This paper contains the German comments on the input of other participants of the SDC2 CG on Evacuation Analyses.

Main Author: Tim Meyer-König (tmk@traffgo-ht.com), TraffGo HT, Germany.

Round: 4

Fig. 2: Duration distribution for an embarkation scenario.

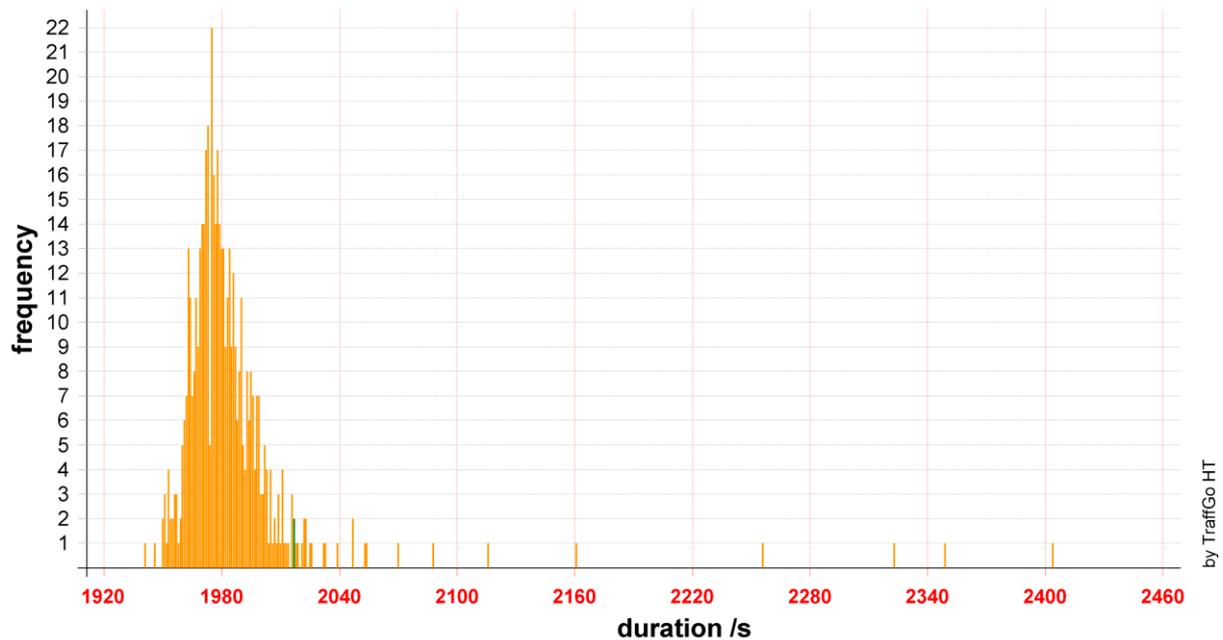
The proposed amount of 500 is indeed arbitrary and only based on experiences gained. However, it is hard to determine, if all relevant possibilities are covered by the proposal made. Fig. 2 shows once again the duration distribution for an embarkation analysis for 500 simulation runs with the green column representing the significant duration. There is no guarantee, that the cases leading to very large durations (spikes beyond 2100 s) are covered by the proposed criterion.

Fig. 3: Ways of statistical evaluations.

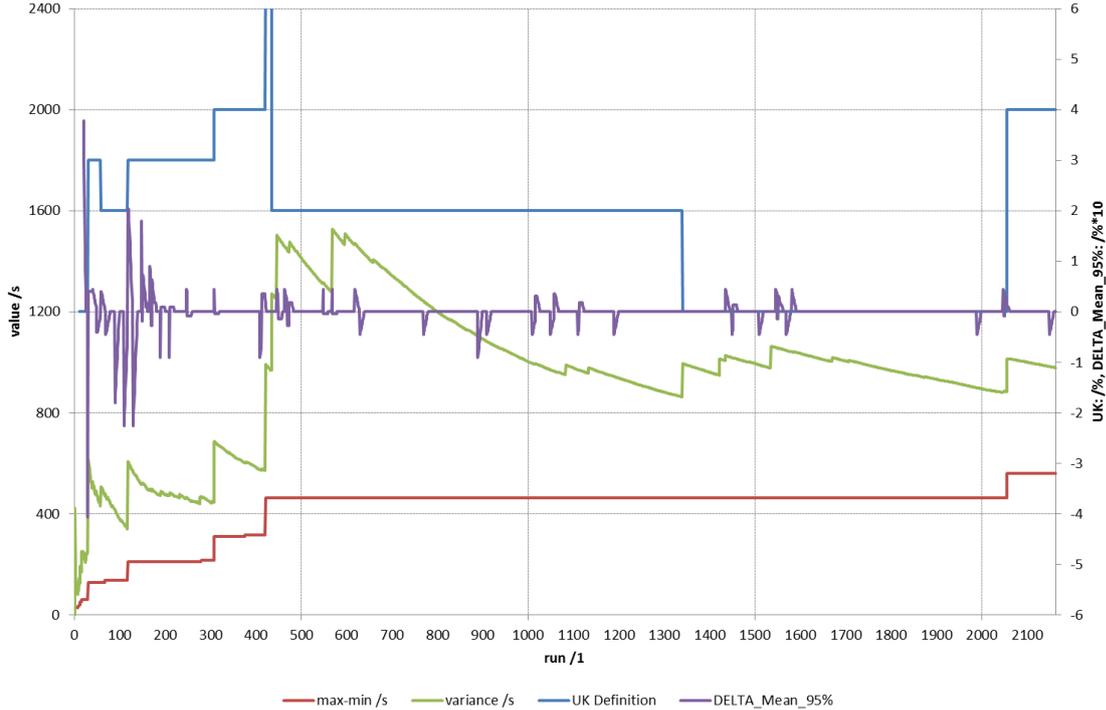
Following, the Scenario was analysed for ~2.500 simulation runs and the results were evaluated in different ways (see Fig. 3).

The convergence criterion proposed by the UK was met within the first 50 runs. At this time, none of the events leading to long durations have occurred. Later on, at around 422 runs, the 5% criterion was suddenly exceeded, so it seems, like this criterion does not lead to a convergence.

Subtracting the max and minimum value showed some kind of convergence and calculating the variance of the results as well, but setting a criterion seems to be a bit arbitrary.

The purple curve shows the per mill, the 95percentile is changing with every additional run. After strong fluctuations in the beginning, the value does not change for 50 runs after 368 simulations, however, these 50 runs are once again arbitrary.

Germany proposes to postpone a decision concerning a convergence criterion until SDC3, so more time is gained in finding one.
